| Project | IEEE 802.16 Broadband Wireless Access Working Group < http://ieee802.org/16 > | |
| Title | Details of SDD Section 11.7 Downlink Control Structure (except 11.7.2.1) | |
| Re: | SDD Session 56 Cleanup, Call for PHY Details | |
| Abstract | This is revised version of Section 11.7 of IEEE 802.16m-08/003r4. This document provides further physical layer details. | |

Figure 1 PBCH Resource Allocation within the sub-frame containing the SFH

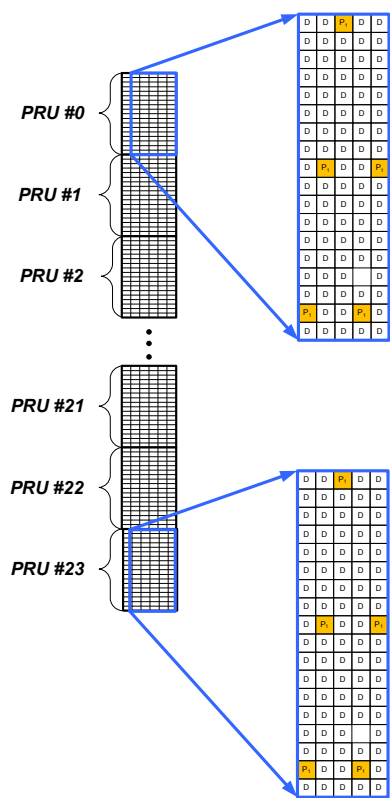
21 ~~The PBCH will be allocated to 2 PRUs in a 5 MHz bandwidth. Of the 24 PRUs available in 5 MHz, the PBCH~~ ← - - -
 22 ~~will be allocated positions 0 and 23 as show in Figure 1 below. The PRUs will utilize the one antenna pilot~~
 23 ~~format defined in Section 11.5 Downlink Physical Structure. The BCH info will be encoded at R=1/8,~~
 24 ~~scrambled by the Cell ID, interleaved, QPSK modulated and mapped to the allocated PRUs.~~

Figure 2 Example Tree-Like Structure for Blind Decoding

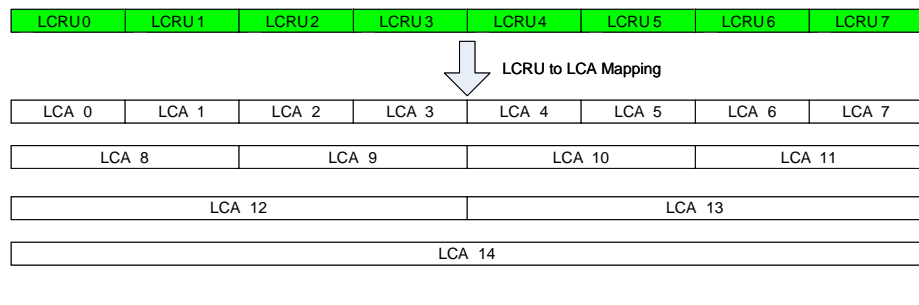
Repetition coding LCRU may be used to achieve effective code rates of $R=1/4$, $R=1/8$ and $R=1/16$. The LCRU over which a single user-specific codeword is mapped is called a Logical Control Allocation (LCA). The applicable coding rate is blindly detected through the aid of a tree like structure. The tree-like structure reduces the search space for the MS. Figure 2 illustrates a tree-like structure in a 4 PRU segment having only 14 possible LCA encodings providing 8 $R=1/2$, 4 $R=1/4$, 2 $R=1/8$ and 1 $R=1/16$ LCA encodings.

Figure 4 USCCH segment Resource Allocation for an Open-Loop USCCH in a Type 1 Regular Sub-frame

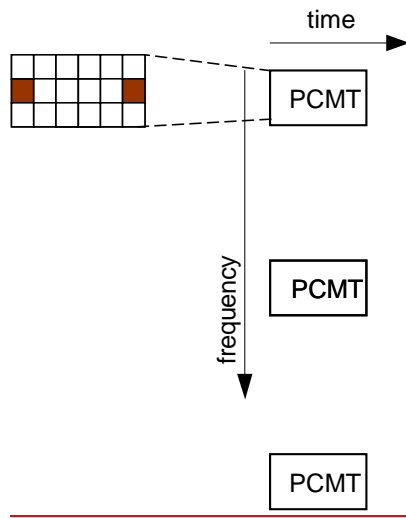
15 For a type 1 regular sub-frame, a USCCH Closed-Loop Segment is comprised of 4 PRUs. These PRUs are
 16 subdivided into 6 PCTs each 3 subcarriers by 6 symbols. Each PCMT contains 2 pre-coded pilots as shown in
 17 Figure 4. 3 PCMTs from different PRUs are grouped to form the LCRU. 8 LCRUs are interleaved over the 4
 18 PRUs allocated to the USCCH Close-Loop Segment.

Figure 5 USCCH segment Resource Allocation for an Open-Loop USCCH in a Type 1 Irregular Sub-frame

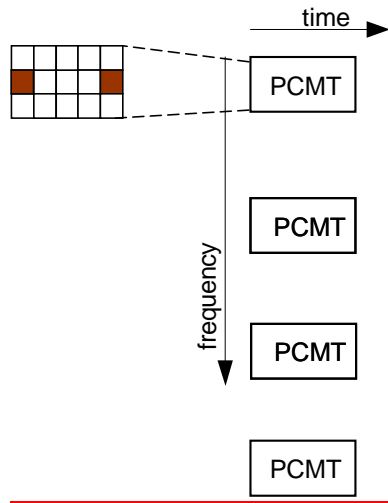
For a type 1 irregular sub-frame, a USCCH Closed-Loop Segment is comprised of 6 PRUs. As before, these PRUs are subdivided into 6 PCMTs each 3 subcarriers by 5 symbols. Each PCMT contains 2 pre-coded pilots as shown in Figure 5. For an irregular subframe, 4 PCTs from different PRUs are grouped to form the LCRU. 9 LCRUs are interleaved over the 4 PRUs allocated to the USCCH Close-Loop Segment.
